2033 4TH AVENUE

EARLY DESIGN GUIDANCE

SDCI #3025502 / JANUARY 2019

summary of review board guidance

1. ENLARGED SECTION AT BAR/LOUNGE

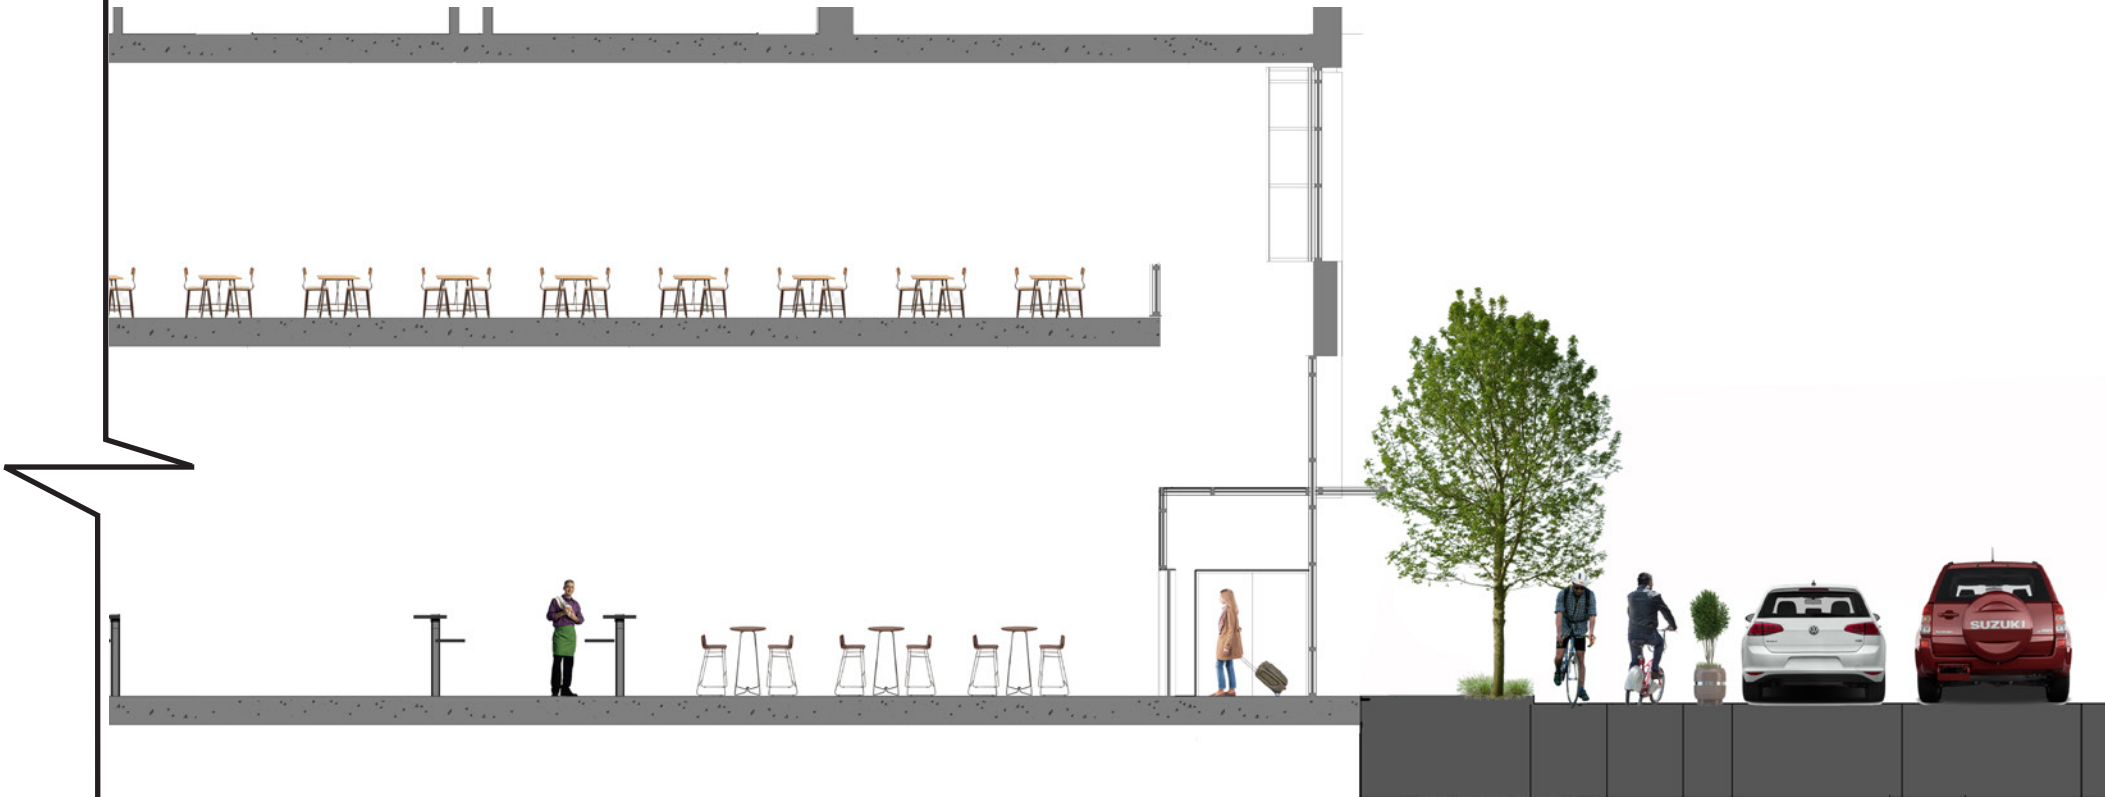
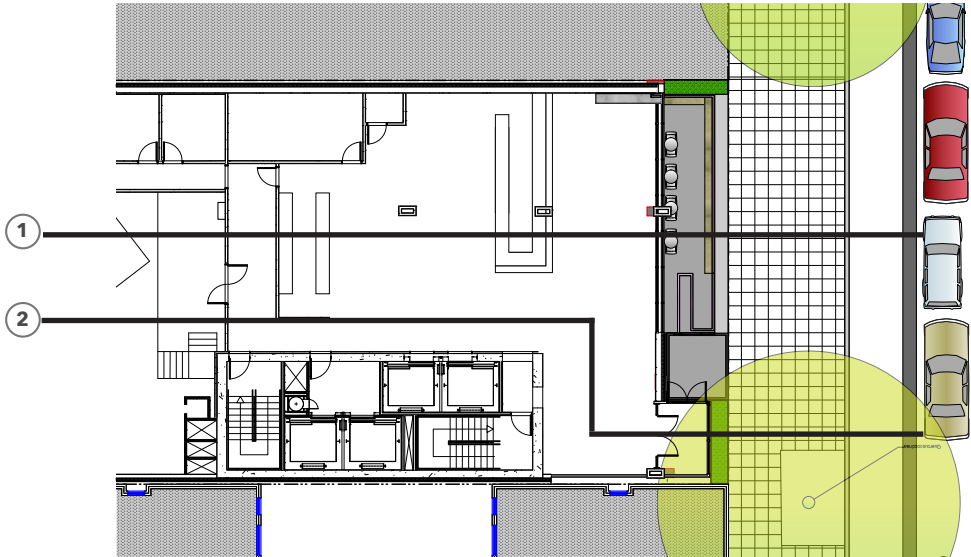
a. While the Board was supportive of the setback and the general idea of a private outdoor space, the Board was split on the proposed wall element. Two Board members were concerned with the wall as it created a perceived barrier to pedestrian interaction, and instead recommended a more transparent frontage. The other Board members supported the design intent to relate the wall to the ribbon concept, and agreed the wall could provide a more intimate outdoor space as well as street interaction, if outdoor seating was provided on both sides of the wall. (B3, C1, C3, C5.1, D1, E3)

In response to the Boards comments regarding the outdoor seating area along 4th Avenue; the design team has modified the design to be more transparent, introducing slatted elements into the bar element. This is in keeping with the linear concept and allows visibility into and through the seating area.

At the first EDG meeting, the board was split on their feelings toward the outdoor seating area in the preferred option. The design team took all opinions into consideration and decided to keep the overall size of the bar, working to make it more transparent allowing for visual interaction between pedestrian and patrons. Incorporating slatted elements into the face of the bar structure, emphasizes its horizontality while providing visibility through the structure and segregation between the bar and sidewalk. Planting is provided to soften the transition between the two uses.

PEDESTRIAN AND BIKE LANE INTERACTION

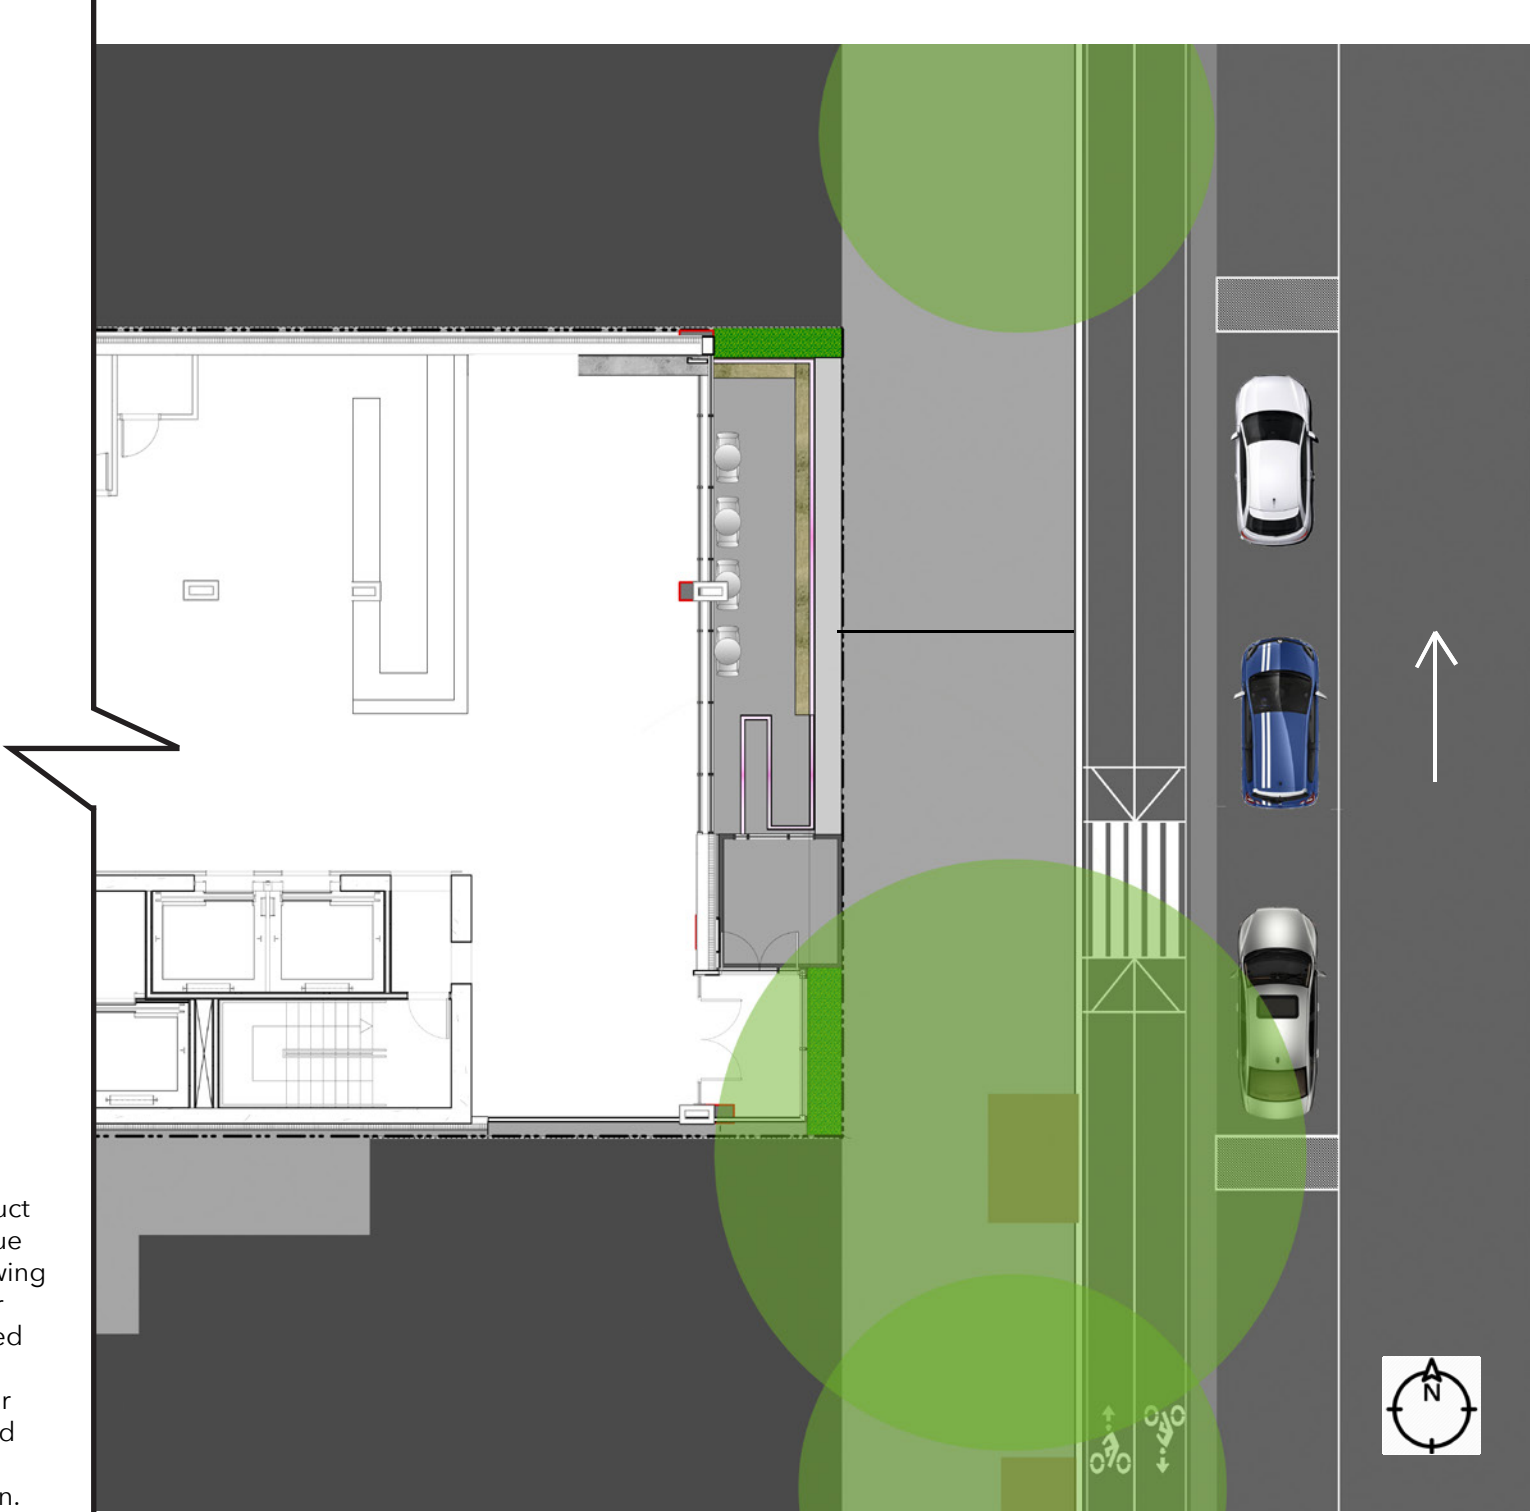
d. The Board also requested more information on the design of the hotel drop off at the next meeting and encouraged coordination with SDOT’s future plans for bicycle improvements. (E1.2, E3)

Coordination with SDOT’s plans for the bicycle lane and the pedestrian drop off/parking lane are included in the site plan and perspectives.

The City of Seattle has plans to construct a dedicated bike lane along 4th Avenue which would flow north to south following the direction of traffic. Similar to other situations within downtown, an elevated and striped section of sidewalk will be utilized to guide pedestrians from their parking lane to the building's hotel and lounge entries while simultaneously slowing bikers with a ramped transition.

EDG #2: OPTION 3(PREFERRED): DEPARTURE PLAN

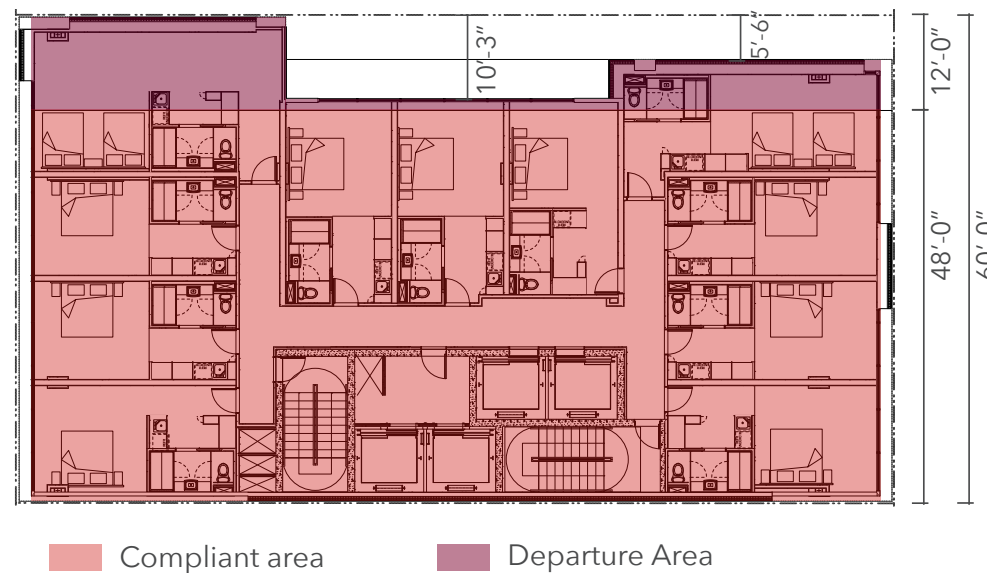
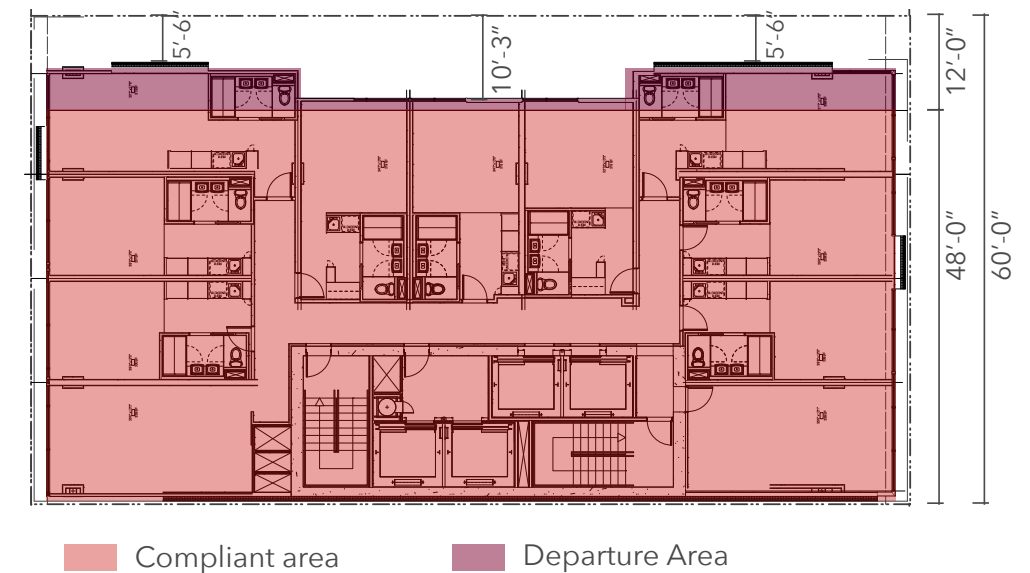
a. The Board indicated they did not support the departure request to increase the maximum tower width as shown. The Board also noted being open to a revised departure request if the justification for the departure was strengthened to clearly result in a better design than could be achieved without the departure. The Board agreed that shifting massing and incorporating setbacks along the south facade to create a consistent facade composition would help justify the departure request. For the next meeting, the Board requested code compliant massing alternate of Massing Option 3 and additional departure analysis documenting the impact a wider tower may have on surrounding context.

The revised preferred concept was strengthened by adding hierarchy and uniformity to the woven ribbon width and height as well as by regulating the north façade elements. By reducing the width of the alley façade to be in alignment with the remainder of the façade, rectilinear form is emphasized, simplifying the solids and voids.

- The additional width at the northwest corner has been eliminated to align with the northeast corner and provide the overall concept a solid feel to the massing. The horizontal elements are projected across the center of the façade to maintain the volume, while stepping the glazing back at the rooms to comply with building code.
